Recommendation to Approve the Roberts' Brothers Townhouse Subdivision Final Plat

ROBERTS' BROTHERS TOWNHOMES

IN RE:)
)
Roberts' Brothers Townhomes Subdivision) KETCHUM PLANNING & ZONING COMMISSION
Final Plat) FINDINGS OF FACT, CONCLUSIONS OF LAW, AND
Date: July 20, 2020) DECISION
)
File Number: 20-020)

PROJECT: Roberts' Brothers Townhomes
FILE NUMBER: P20-032
APPLICATION TYPE: Townhouse Subdivision Final Plat
APPLICANT/OWNER: Roberts Duplex #2, LLC (John C Roberts per Blaine County Assessor)
REPRESENTATIVE: Benchmark Associates
REQUEST: Final Plat to subdivide a duplex development into two townhouse sublots
ASSOCIATED APPLICATIONS: Design Review P18-018, Townhouse Subdivision Preliminary Plat P18-047, Building Permit 18-021
LOCATION: 205 Aspen Drive (Warm Springs Village 3rd Addition: Block 3: Lot 3)
ZONING: General Residential – Low Density (GR-L)
OVERLAY: Avalanche

PROJECT NO. 18008	DWG BY: DWS/CPL	18008PG1.DWG
FINAL PLAT	DATE: 04/16/2020	SHEET: 1 OF 2

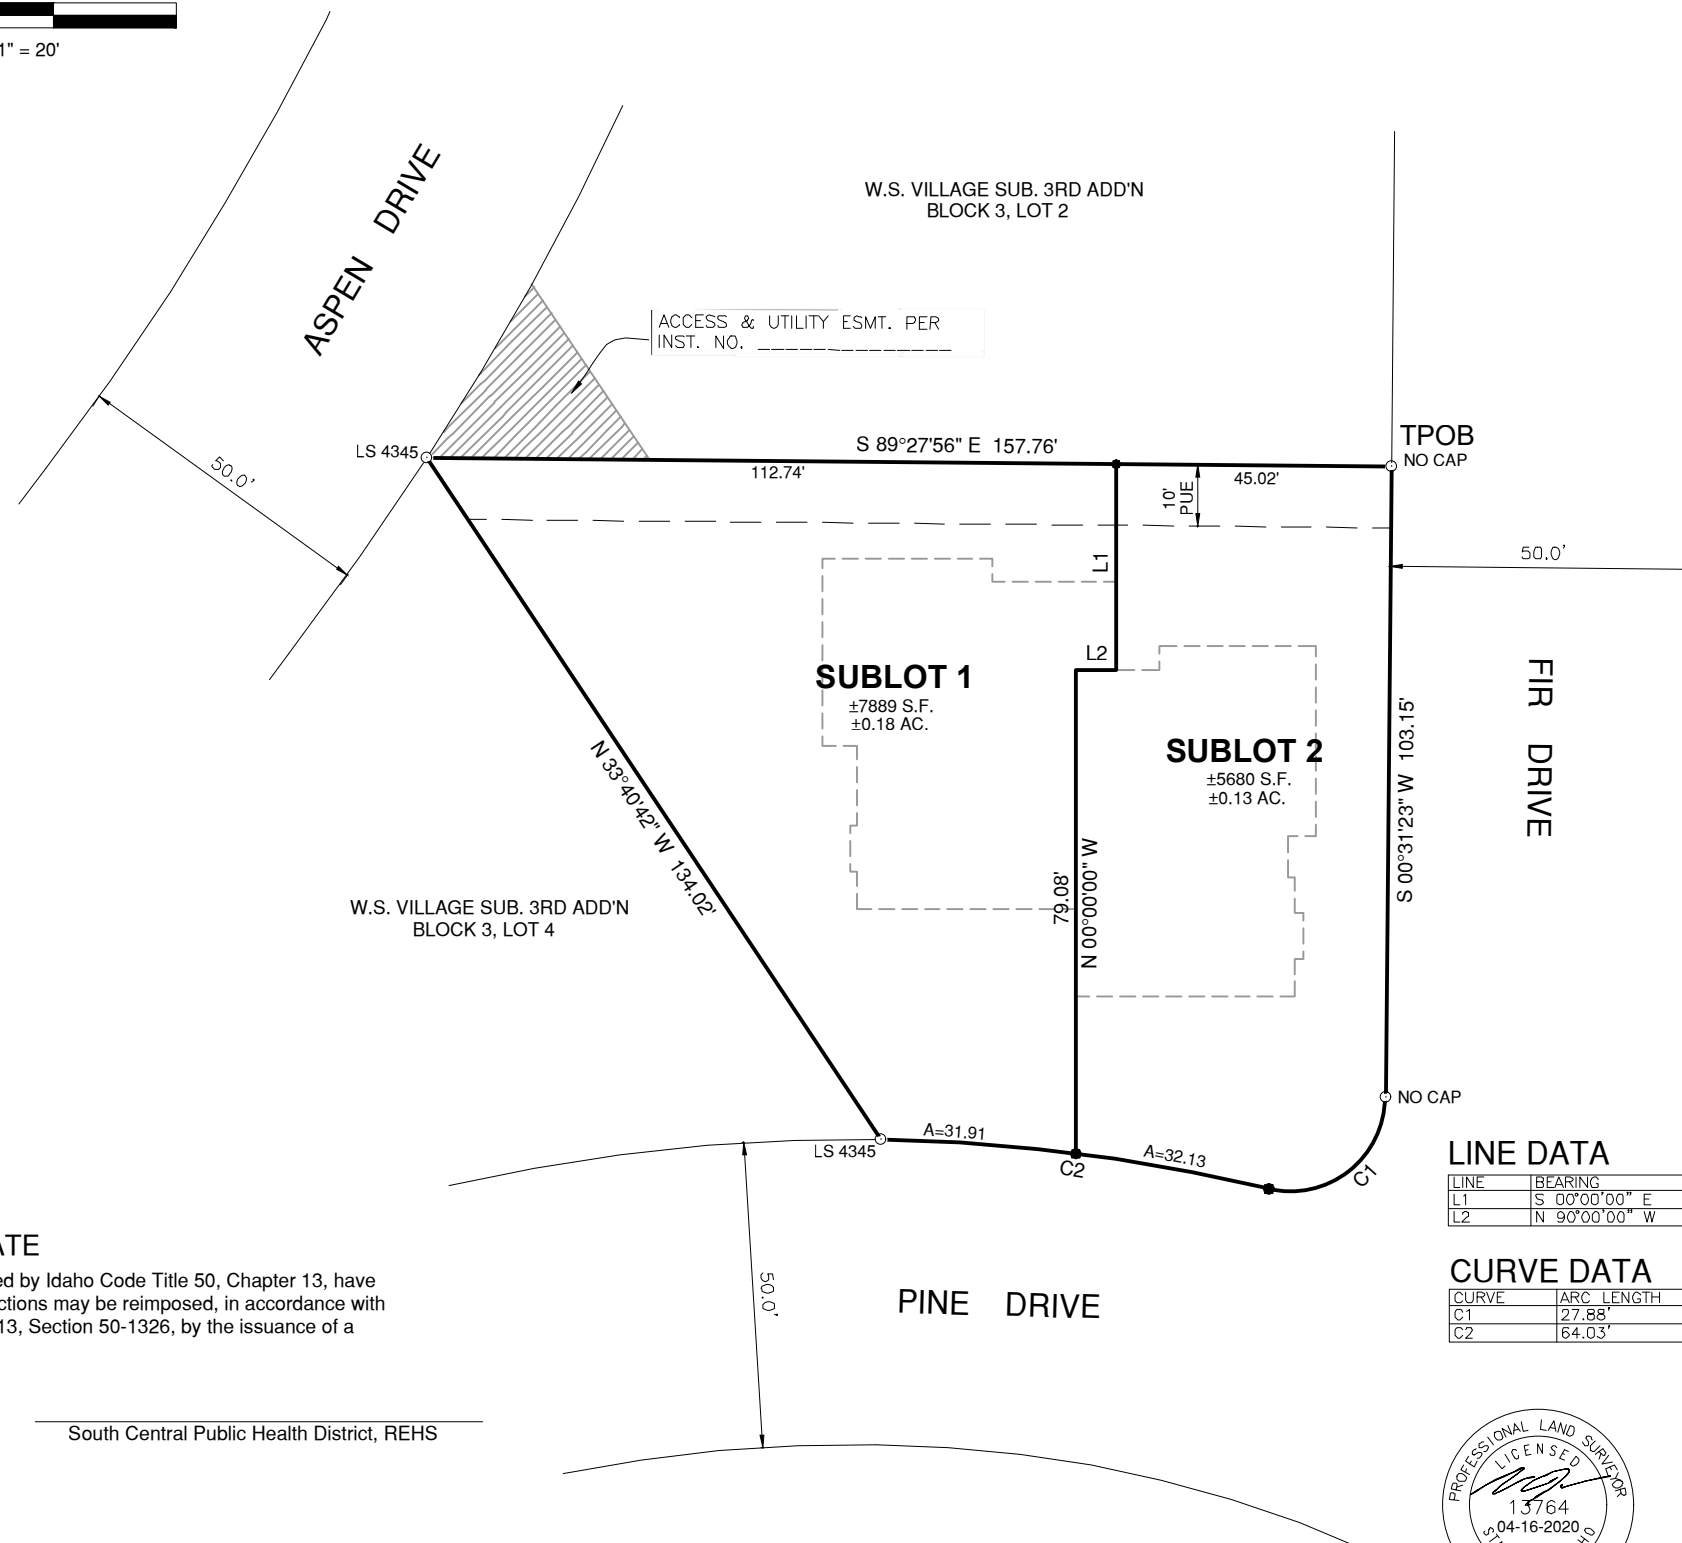
2. The Final Plat mylar shall visually represent the 5 ft public utility easement as required pursuant to KMC §16.04.030.J10.
3. The recorded plat shall show a minimum of two Blaine County Survey Control Monuments with ties to the property and an inverse between the two monuments. The Survey Control Monuments shall be clearly identified on the face of the map.
